Subject: Transmittal of Class 1 Permit Modification to Update Figures in the Los Alamos National Laboratory (LANL) Hazardous Waste Facility Permit, EPA ID No. NM0890010515

**CLASS 1 PERMIT MODIFICATION NOTIFICATION
STRUCTURE CHANGES AT TECHNICAL AREA 54**

ENV-DO-14-0023

LAUR-13-29257

Figure 7: Technical Area 54, Area L, Security Fences, Entry Gates, and Entry Stations

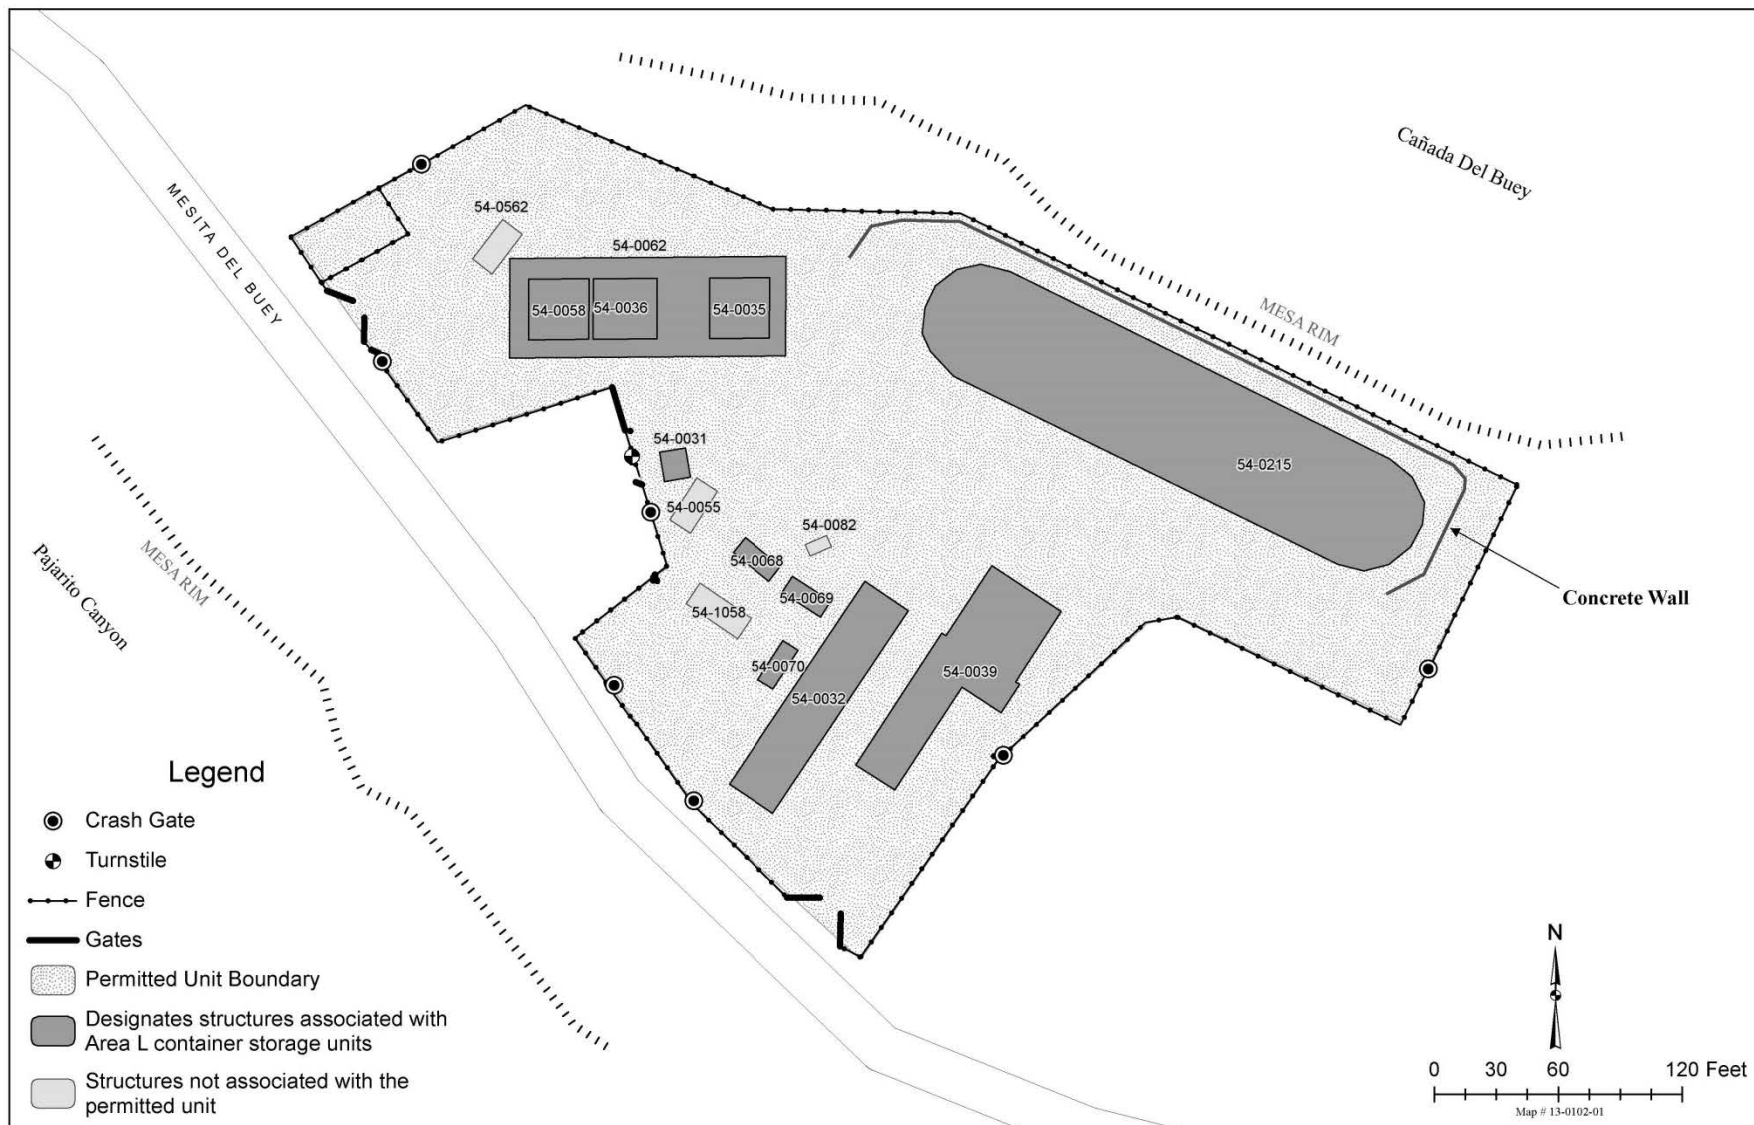
Figures 7 (Technical Area 54, Area L, Security Fences, Entry Gates, and Entry Stations) and 26 (Technical Area 54, Area L, Container Storage Unit) of Permit Attachment N, were revised to remove structure 54-46, the temporary fence, and the outline for the Perma-Con® located at the south end of structure 54-0032. As stated in the *Request for Class 2 Permit Modifications to the Los Alamos National Laboratory (LANL) Hazardous Waste Facility Permit* letter dated March 29, 2007, a proposal was made to relocate the Perma-Con® from the 54-36 structure to the 54-32 structure. The Perma-Con® was not relocated and was decommissioned instead. Additionally, the temporary fence shown in Figure 26 of Attachment N was not erected and therefore is not included in the revised figure. Structure 54-46 was removed from Area L; however, the structure was not designated as a structure that managed hazardous waste associated with the Area L container storage unit. Structure 54-0562, also not designated as a structure that manages hazardous waste associated with the permitted unit, has been added to Area L.

Figure 27: Technical Area 54, Area G, Container Storage Units

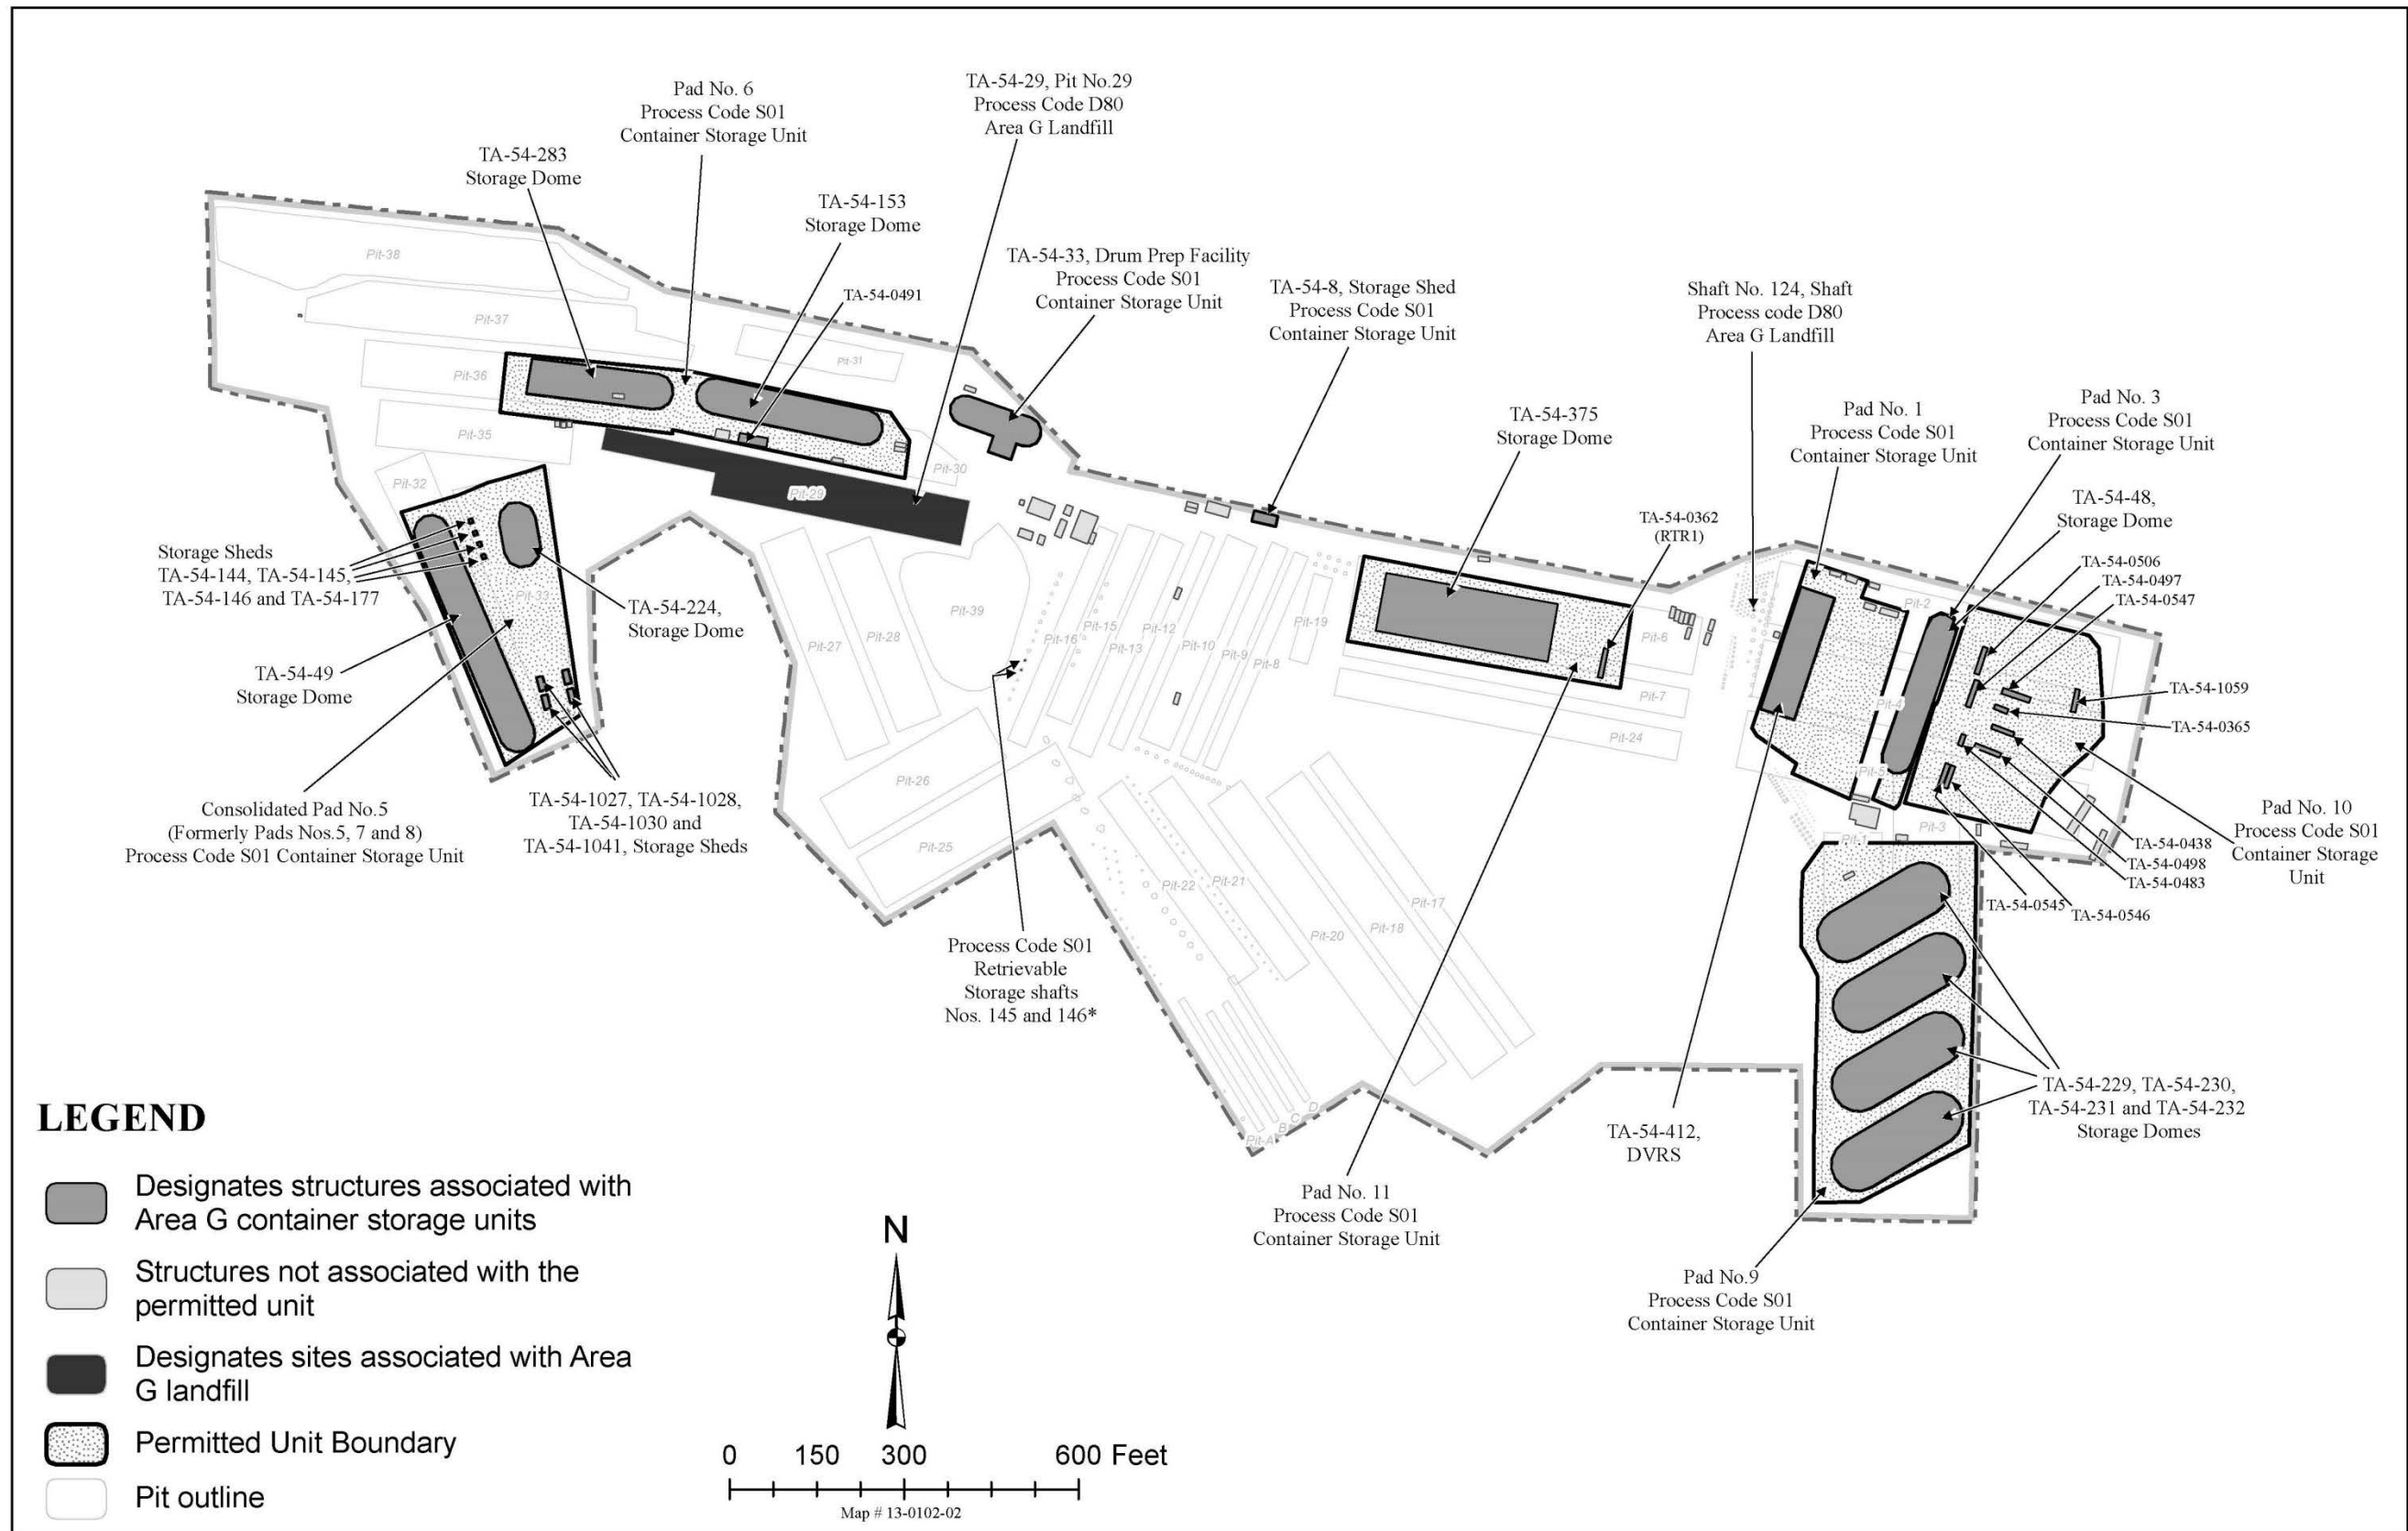
Figure 27 (Technical Area 54, Area G, Container Storage Units) of Attachment N was revised significantly to either remove structures that have been relocated or removed completely from Area G, to show the placement of new structures at Area G, or to label existing structures. Additionally, as a result of the Figure 27 update, some of the larger scale figures for units at TA-54

- Consolidated Pad No. 5- One of the five storage sheds was removed from the northern part of the pad, and two structures were removed from the center of the pad. All three structures removed were designated as structures that were not associated with the permitted unit and were not used to manage hazardous waste.

- Pad No. 6- Structure 54-0491 is a structure that is used for the storage of hazardous waste; however, in Figure 27 it was not identified as such nor was it labeled. The update to this figure includes labeling of Structure 54-0491 and designating it as a structure associated with the permitted unit. Storage Sheds 54-522 and 54-523 were removed from Pad 6 and Figure 27 has been updated to reflect this change. Storage Sheds 54-522 and 54-523 were designated as structures that were not associated with the permitted unit and were not used to manage hazardous waste.

- Pad No. 11- Pad 11 had three concrete barriers which are no longer present; therefore the two barriers were removed from Figure 27. Structure 54-0362 (RTR1) is associated with the permitted unit; however in Figure 27 it was not identified as such nor was it labeled. The update to this figure includes labeling of Structure 54-0362 (RTR1) and designating it as a structure associated with the permitted unit.

- Pad No. 9- Storage Shed 54-574 was moved and is currently located north of Dome 232. Storage Shed 54-484 was removed from the pad. Both 54-484 and 54-574 are designated as structures that are not associated with the permitted unit and are not used to manage hazardous waste.

- Pad No. 10- The structures located on Pad 10 were not labeled and were not clearly identified as structures used to manage hazardous waste. Figure 27 was updated to label the structures and to identify them as structures associated with the permitted unit.

Figure G.8-1: Technical Area 54, Area G, Pad 5, Outdoor Container Storage Unit Soil Sampling Grid and Additional Sampling Locations

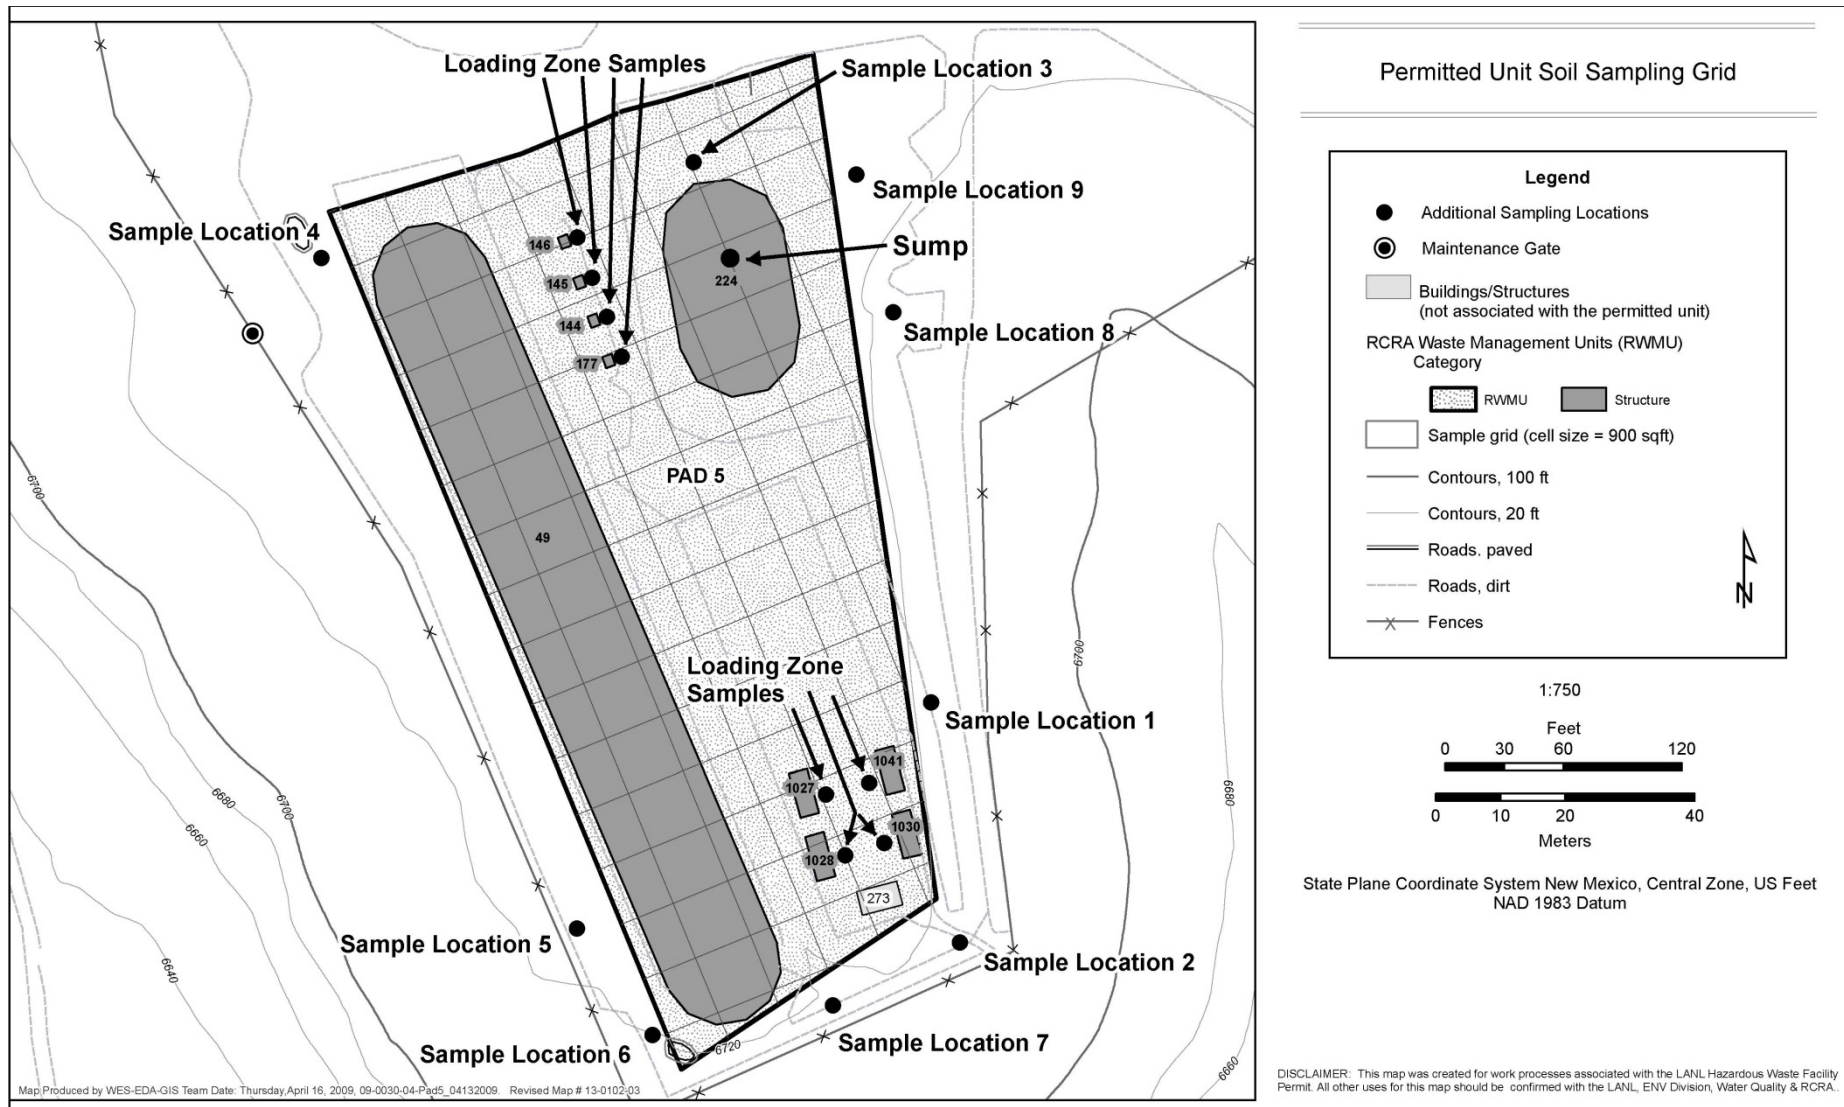
Figure G.8-1 (Technical Area 54, Area G, Pad 5, Outdoor Container Storage Unit Soil Sampling Grid and Additional Sampling Locations) of Attachment G.8 and Figure 32 (Technical Area (TA)-54, Area G, Pad 5 (Domes 49 and 224; Storage Sheds 144, 145, 146, 177, 1027, 1028, 1030 and 1041) of Attachment N, were modified to remove structures 54-465, 54-527, and 54-356. These structures were removed from the pad and Figures G.8-1 and 32 were updated to reflect this change. Additionally, a maintenance gate, located on the west side of the fence line was added to the figures. This change is consistent with the current Figure 8 of Attachment N.

Figure G.9-1: Technical Area 54, Area G, Pad 6 Outdoor Container Storage Unit Sampling Grid and Additional Sampling Locations

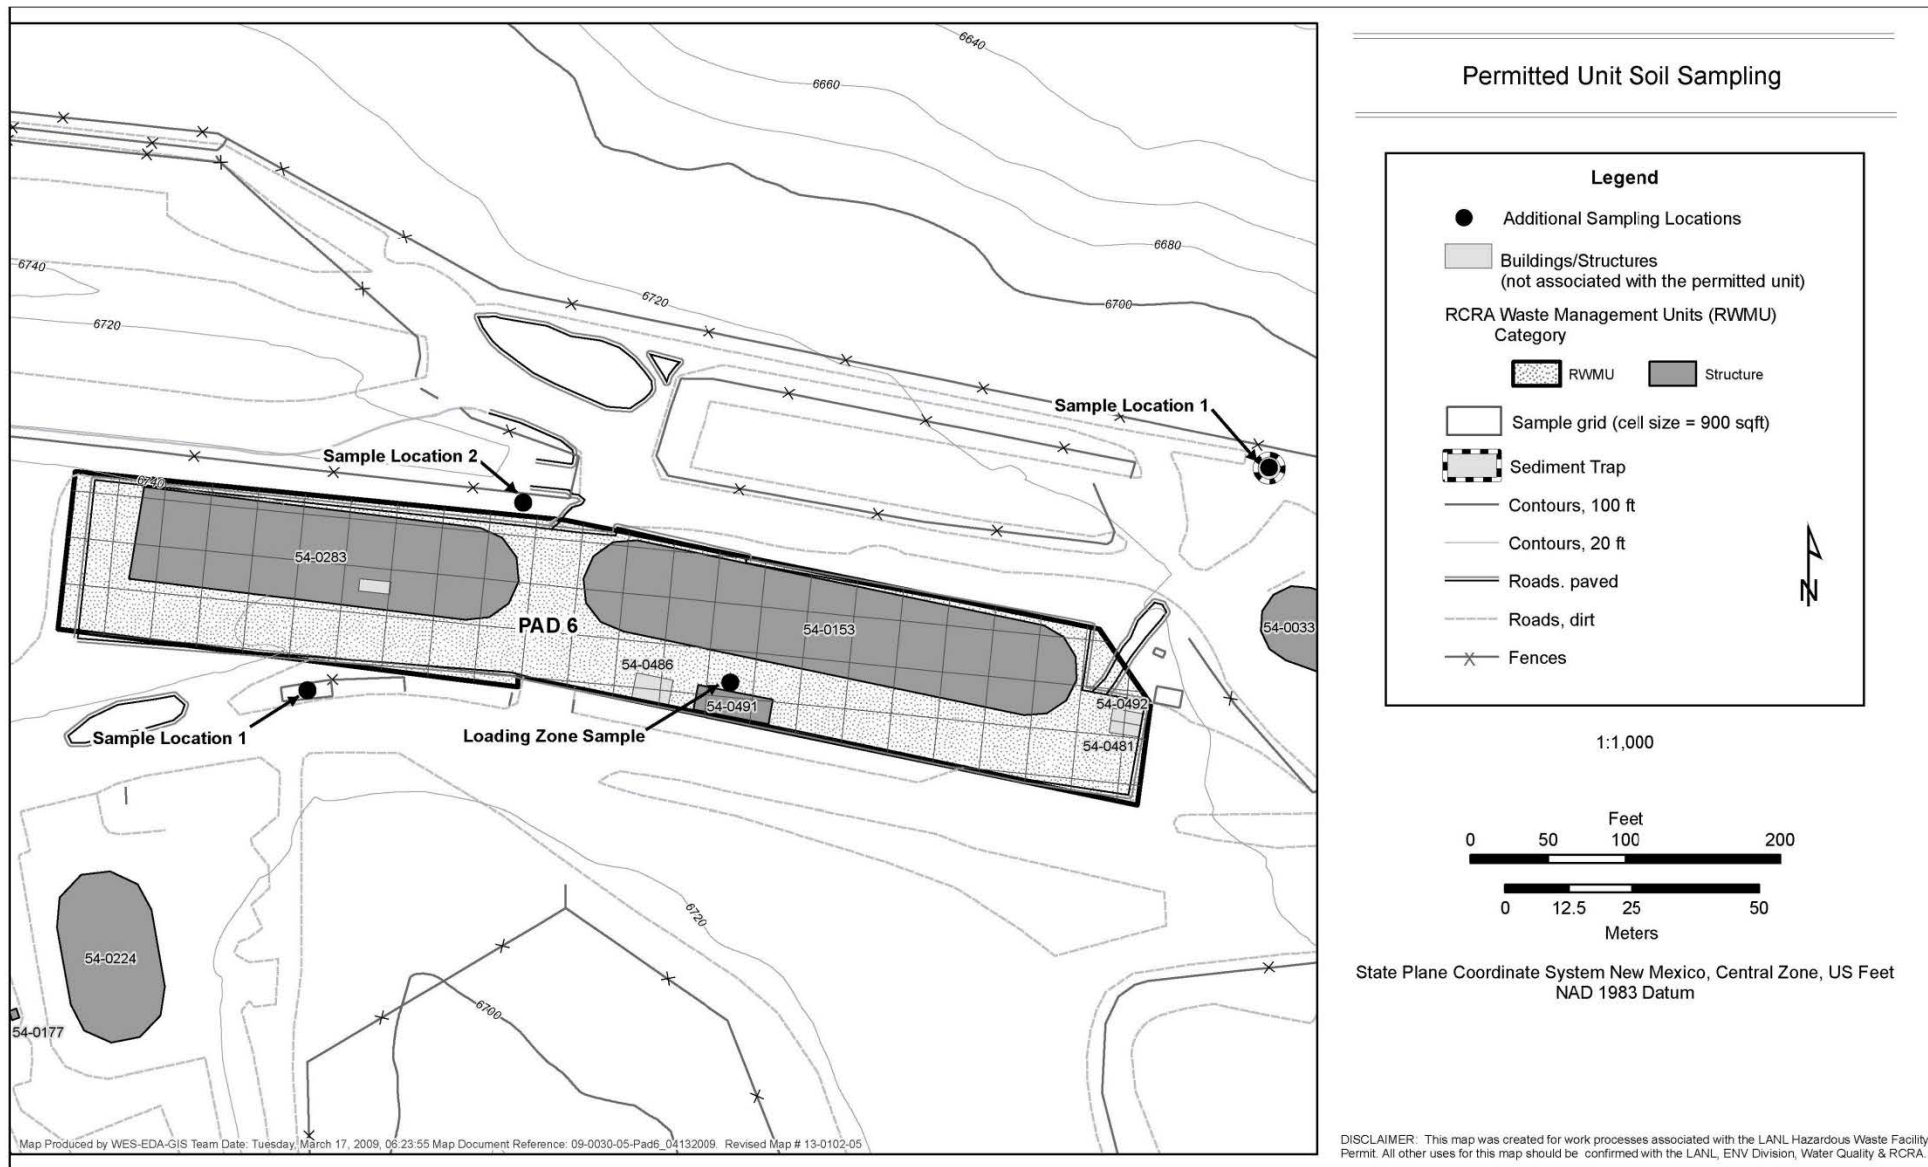
Figure G.9-1 (Technical Area 54, Area G, Pad 6 Outdoor Container Storage Unit Sampling Grid and Additional Sampling Locations) of Attachment G.9 and Figure 33 (Technical Area (TA)-54, Area G, Pad 6, (Domes 153 & 283)) of Attachment N were revised to remove structures 54-522 and 54-523. These structures were designated as structures that were not associated with the permitted unit and were not used to manage hazardous waste. The figure was also updated to reflect the addition

of a structure on the inside of structure 54-0283 that is not used to manage hazardous waste at the permitted unit.
